FIRST REVIEW  
WC<sup>3</sup> Project #: 217-525-139

Subject: Powder Mountain Parcel 4 Ftg Found – Plan Review Comments

**Project Name:** Powder Mountain Parcel 4 Ftg Found

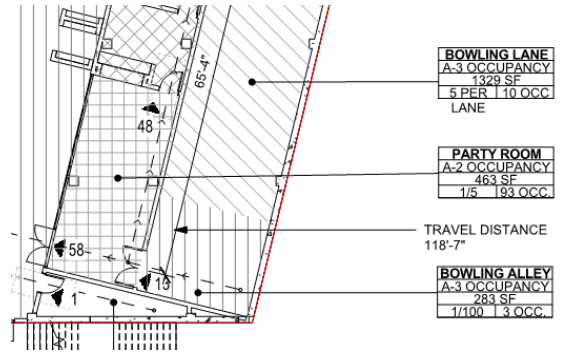
- III. Per IBC 1016.2 Item 5, occupants are not permitted to exit through kitchens. However, the occupants from the party room appear to be exiting through this space. Please address.

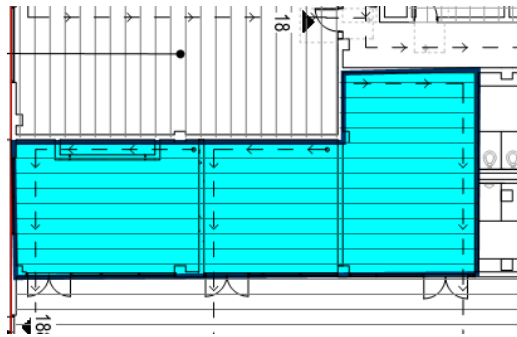
- a. The party room is also required to provide a second exit from this space, per IBC Table 1006.1.2. Please address.

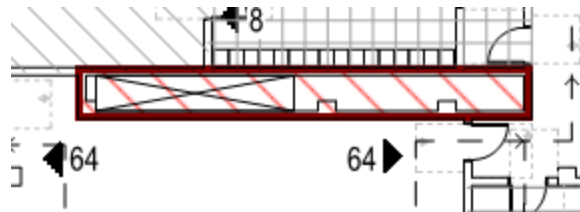
- IV. Please clarify the occupant load of the below highlighted spaces. It appears no occupant load has been assigned to these areas.

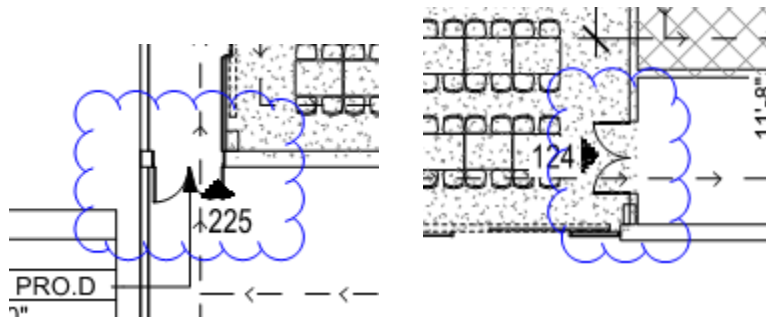
- I. Per IBC 1028.1, occupants are not permitted to re-enter the building. However, it appears that both the occupants from the terrace area and the occupants from the multi-use space will re-enter the building. Please make all necessary corrections.

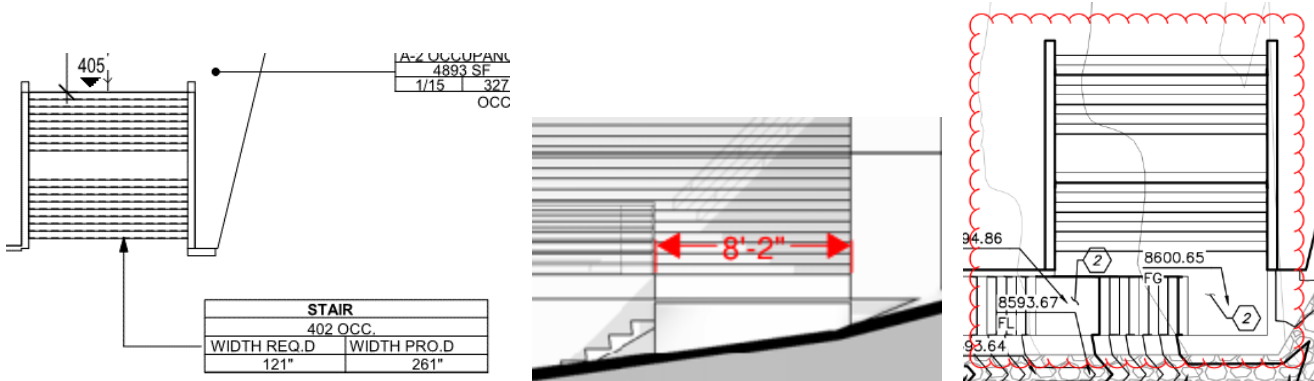
- III. The stair shown below is noted to have 405 occupants assigned to it. However, in the elevation drawings, a guardrail is placed directly at the bottom of the stair run, reducing the egress width to 96-inches. Per IBC 1005.4, the minimum required width of the means of egress is not permitted to be reduced. Please make all necessary corrections to the plans.
- a. In addition to the above comment, IBC 1011.6 requires that the landing provided at the top and bottom of each stairway be not less than the width of the stairway served. Please address.

D. Detail 4: Please address the following:

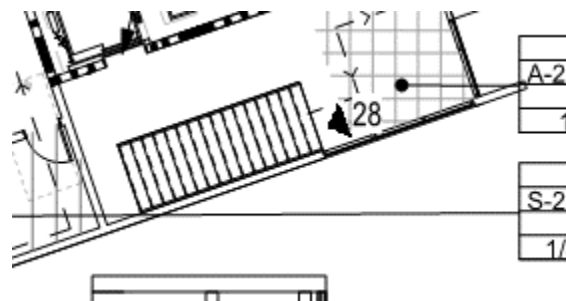
- I. The stairs provided within the lobby appear to be constructed as exit access stairs. Please provide complete details showing compliance with IBC 1019.3.
  - a. It appears these stairs may connect the upper ground level, ground level, and upper basement. Please clarify.

B. Detail 4: Please address the following:

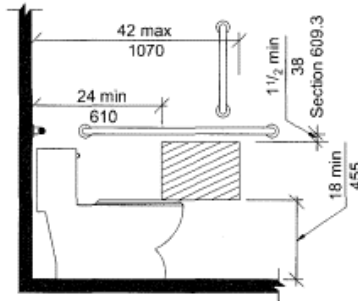
- I. Several notes appear to overlap with one another. Please address.
- II. Please show the location of the vertical side water closet grab bar as provided for in Section 604.5.1 of ICC A117.1-2009.
- III. Please provide complete dimensions for the location of the toilet paper dispenser in accordance with Section 604.7 of ICC A117.1-09.

A8. Sheet A05.02: Please address the following:

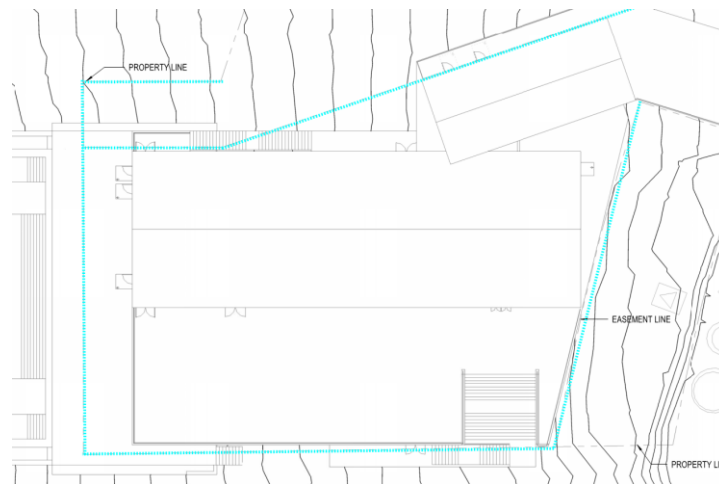
- A. It appears that the property line and easement lines cut across the proposed structure. Please make all necessary corrections to the plans.

B. Fire Separation Distances: Please address the following:

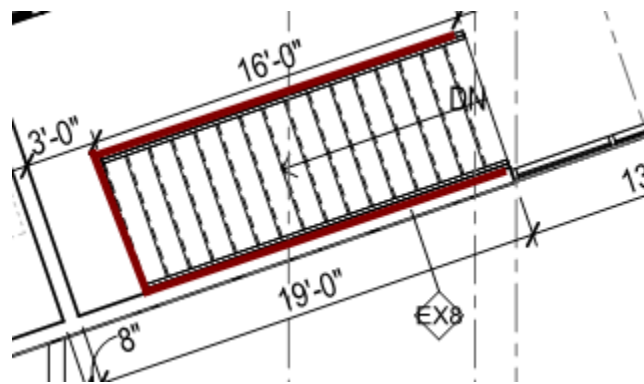
- I. Please provide dimensions to the property lines and easement lines specified on the plans. This distance shall be measured at right angles from the face of the wall.
- II. Based upon the FSD, additional fire ratings for the exterior walls of the buildings may be required, in accordance with IBC Table 602.
  - a. Any wall within 10 feet will be required to be protected from the interior and exterior of the wall.
- III. Please provide a separate opening analysis for each building on the site. The analysis shall be based upon the separation distances determined in accordance with above definition and IBC Table 705.8.
